SpaceFiber

- activities in Japan -

Comments for SpaceFiber Specifications

2012 Oct.

- 5.3.2.2 SpaceWire Null

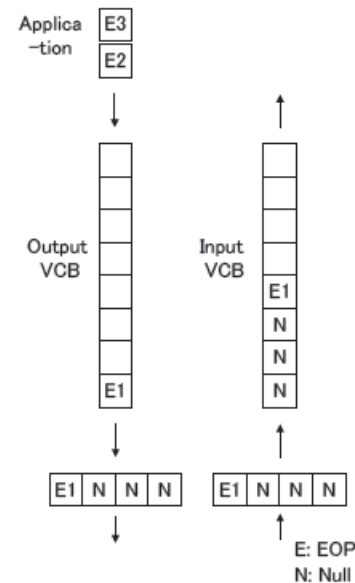
- SpaceWire Null

- If VCB's width is 8bit and EOPs are putted one by one on output VCB, input data rate is increased up to 4 times of the output rate. Isn't it problem? However, this case is caused in low speed, so it may be not problem.

- c. When the data available from the output virtual channel buffer to be put in the data frame is not a multiple of four N-Chars, Null symbols shall be added to the end of the data field to pad the last word out to a complete data word.
- d. Nulls shall be transported across the SpaceFibre link and placed in the input virtual channel buffer at the receiving end of the link.

“Null” is changed to “Fill” in draft E.
“Fill” should be removed at the destination.
To avoid waste of bandwidth.

• Lane Initialisation State Machine

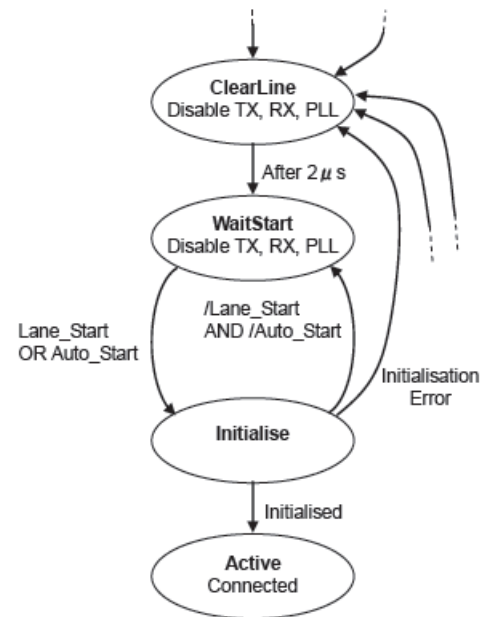
– States' Mismatch ?

- In Initialise super-state, receiving and sending control words are needed to change state.
- On the other hand,
 - In WaitStart State, disable TX, RX, PLL,
 - In Active State, enable TX, RX, PLL.

– Lack of description

- “Lane_Start” and “Auto_Start” have to be defined.

Enabling sequence should be defined.
Improved in Draft E

• Receive Synchronisation State Machine

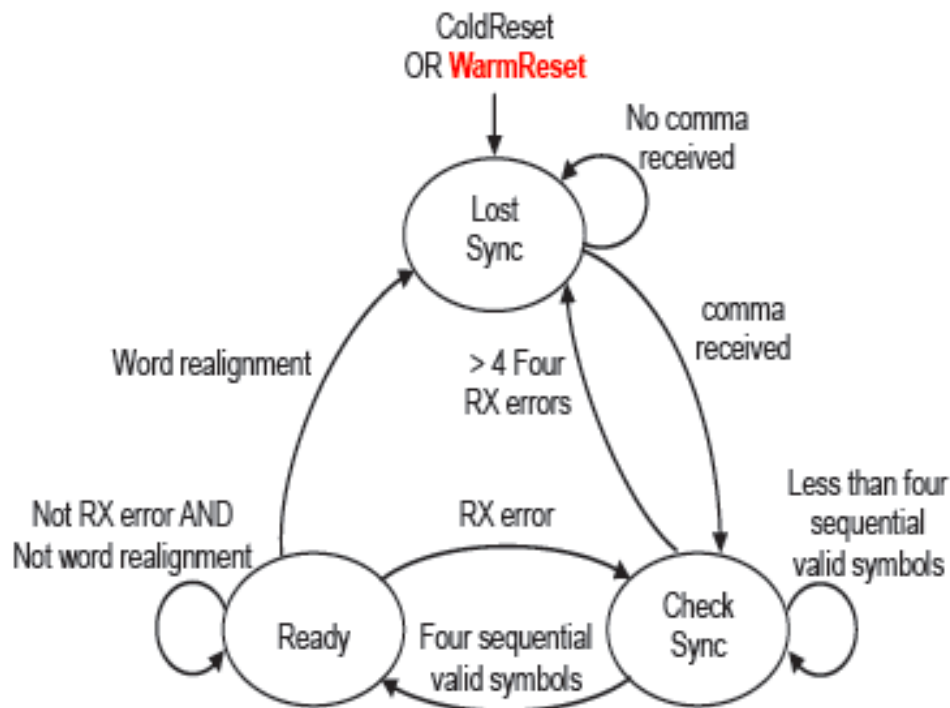
– Description's Mismatch

- Fig5-11: WarmReset is asserted, move to **LostSync** state.
- 5.10.3.2.2 c.2: When WarmReset is asserted, move to the **CheckSync** state.

Flexible state machine based on 32bit-input

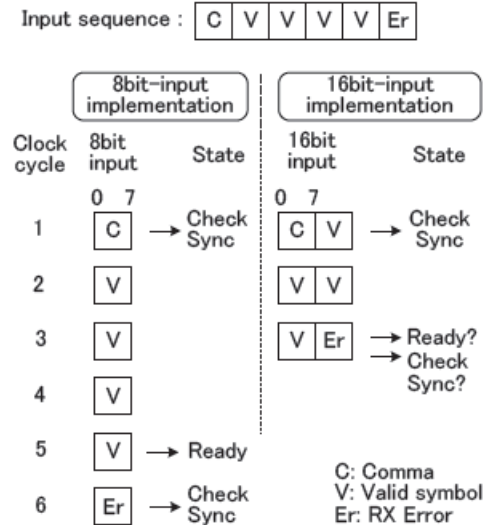
- Receive Synchronisation State Machine
 - It is supposed that the state machine is based on 8bit-input implementation.
 - Therefore, in the 16bit-input implementation, in order to achieve the transition to the same state for the same input sequence, it is necessary to double the 16bit-input clock rate.
 - As well, in the 32bit-input implementation, the state machine's clock rate have to be four times of 32bit-input clock rate.
 - It can be avoid by the state machine based on the 32bit-input implementation.
 - In addition to that, flexibility of the number of symbols is needed (e.g. State changes by 4-7 sequential symbols.)
 - By the flexibility, the state can change in the 32bit boundary, regardless of the position of the comma code.

Behavior of the sequencer is not the same for 8/16/32 bit implementations. It seems to be taken into account in Draft-E.
